CITY OF BETHLEHEM BUREAU OF PLANNING AND ZONING

April 6, 2022

(21-003 LD&S) - 21020002-SOUTH NEW STREET APTS - 319-27 S. NEW STREET - Ward 3, Zoned CB, plan dated October 29, 2020 and revised February 21, 2022.

A-101

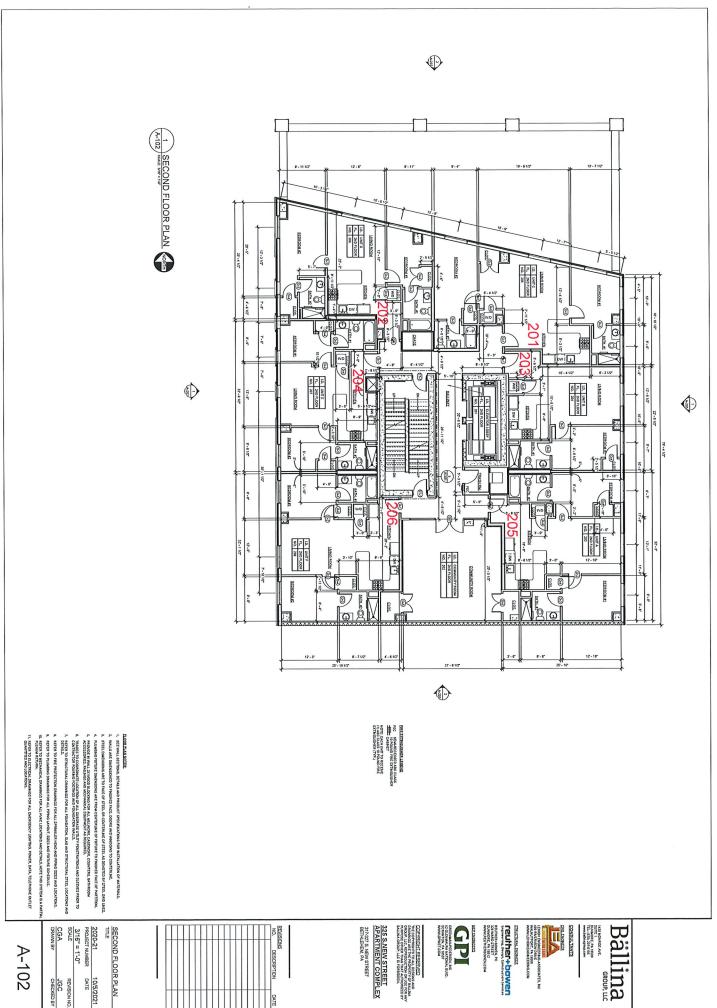
- c. Clarify what line 8, Access Ramp, is for.
 - d. Add item for ADA ramp upgrades at S New and E Graham Pl. This shall have a unit cost of \$10,000.
- 8. Please see attached addressing plan. All addresses/apartment numbers shall be clearly displayed at the entrances.

1st floor retail will utilize an address of

319 S New St Bethlhem, PA 18015

A-105

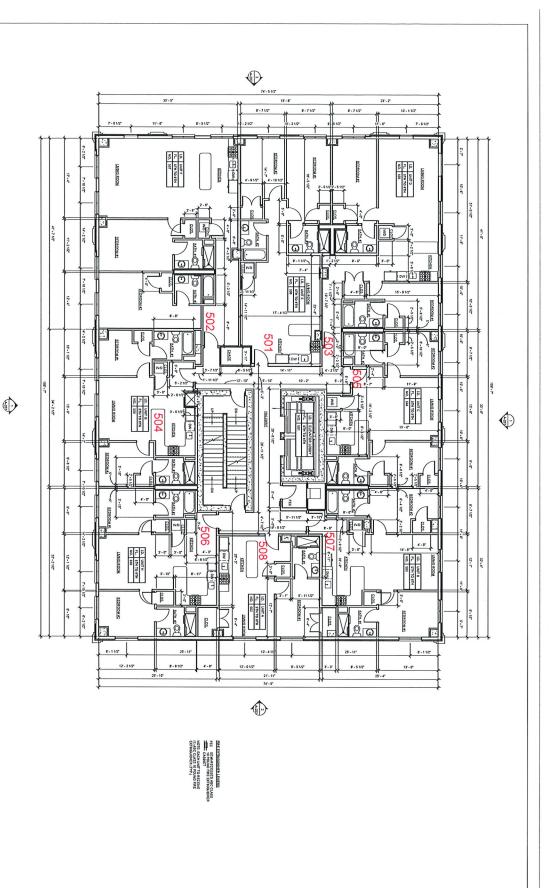
floors 6 through 9 will follow same addressing
